NUMBER: 23-035-21

Rattle Coming From Sunroof

This bulletin involves replacing the sunroof fasteners.

2013 - 2021	(WD)	Dodge Durango
2013 - 2021	(WK)	Jeep Grand Cherokee

**Fig. 1
Sunroof Fasteners**

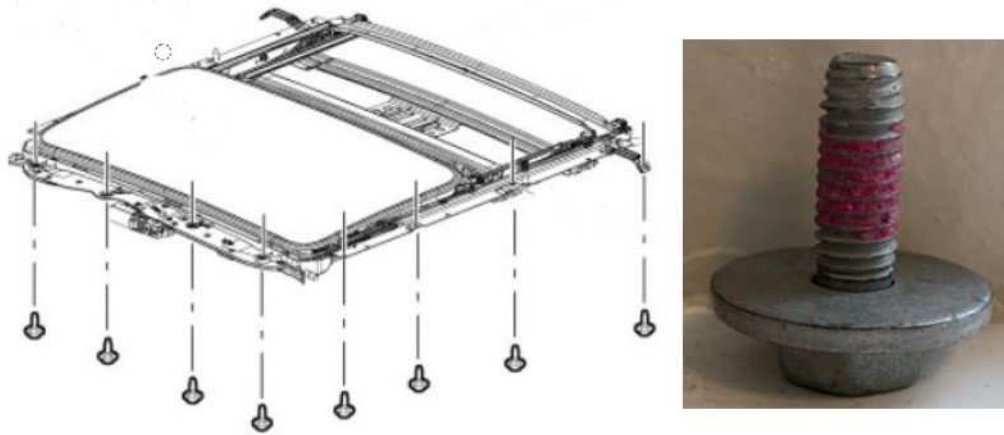
4. Loosen the sunroof fasteners attaching the sunroof assembly to the roof panel but **do not remove them (Fig. 1)** .

5. Replace each one of the 12 or 14 sunroof fasteners with new fastener P/N 06513746AA (Fig. 1) one at a time, without removing the sunroof module. Tighten fasteners to 9 N·m (80 in. lbs.).
6. Install the lowered headliner. Refer to the detailed service procedures available in DealerConnect> Service Library under: Service Info>23 - Body / Interior / Headliner / Installation.
7. Connect the battery negative cable.
